**CITY OF KELOWNA**  
**MEMORANDUM**

**APPLICATION NO.** Z07-0025

**PURPOSE:** TO REZONE THE SUBJECT PROPERTY FROM THE C4 –  
URBAN CENTRE COMMERCIAL ZONE TO THE C7 – CENTRAL  
BUSINESS COMMERCIAL ZONE IN ORDER TO CONSTRUCT  
A NEW FOURTEEN STOREY MIXED-USE  
COMMERCIAL/RESIDENTIAL BUILDING ON THE SUBJECT  
PROPERTY

**MIXED USE BUILDING  
HIGHWAY 33 & RUTLAND ROAD  
KELOWNA, B.C.**

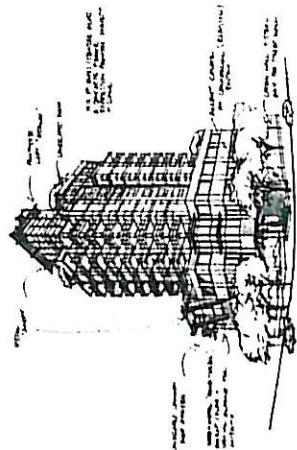
b) To parapet of stair penthouse providing access to landscaped rooftop amenity: 47.4 m.

Variance: 3.4 m.

The lowest average grade at the building face is 0.8 m. below the elevation of the entry level of the building. The height measured from the entry elevation of the building to the general height of the roof parapet is then 44.3 m. Given the desire to provide a rooftop amenity, and allowing for the possibility of a rooftop chilling unit (should this be necessary to supplement the geothermal system for cooling<sup>1</sup>) items expected to exceed the 44.3 meter height are: the rooftop access stair penthouse and associated storage room (for storage of rooftop furnishings), the chilling unit and its enclosure (shown as a blue "box" on the elevations), the parapet of the glazed two-storey penthouse "beacon" which marks the important Highway 33 / Rutland Road intersection, the proposed rooftop hot-tub deck, and the glazed guard rail and planters enclosing the rooftop deck. Of these items, the highest is the access stair penthouse and associated storage room which accounts for approximately 4 ½ % of the area of the roof.
